Sydney Modern Project Further Acoustic Clarifications

Arup Acoustics has reviewed the request for further information from Department of Planning & Environment and the submissions related to acoustics commissioned by the Wharf Terrace Apartments.

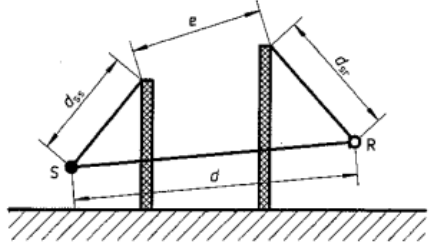
“Please provide a response to the PKA acoustic report regarding calculated noise impacts and noise criteria, in particular the potential need for additional acoustic treatments and potential impacts from the multi-purpose room/outdoor space.”

Noise attenuation from outdoor café to 10 Lincoln Crescent is calculated based on ISO 9631-2:1996 *Acoustics – Attenuation of sound during propagation outdoors – Part 2: General method of calculation*, including distance loss and acoustic screening effects with double diffraction. The calculation and assumptions are provided in the table below:

Items	Sound Level or correction factor	Remarks
Sound Power Level of the entire outdoor café area	105 dB(A)	
Distance attenuation $A_{div} = 20\lg(d)+11$	-46.6 dB	$d=60$ m
Directivity correction, D_c	+3 dB	
Screening attenuation for double diffraction, A_{bar}	-23 dB	There are two elements can provide barrier effect between source at outdoor cafe and residential receiver: 1. According to the markup provided in Figure 1 of Acoustic SEARs report, people has been restricted from the edge of the outdoor café by garden, and it has been assumed that people are distributed in the entire outdoor café area (i.e. not all standing at the boundary); Thus, it is appropriate to assume the equivalent averaged source location is at the middle of outdoor café (~15m from the boundary). 2. The carpark building in front of the residential building provides barrier effects. In accordance with ISO 9631-2:1996, the double barrier attenuation has been calculated using the double diffraction method provided in the standard as shown in the figure below:  Figure 7 — Geometrical quantities for determining the pathlength difference for double diffraction (ISO 9631-2:1996 Figure 7)

Contingency allowed for occasional speeches	+5 dB	
SPL @ closest residential receiver of 10 Lincoln Crescent	43 dBL _{Aeq,15min}

As such, we can confirm that additional acoustic treatments are not required for the outdoor café space under the assumptions specified in Acoustic SEARs Report Rev H.
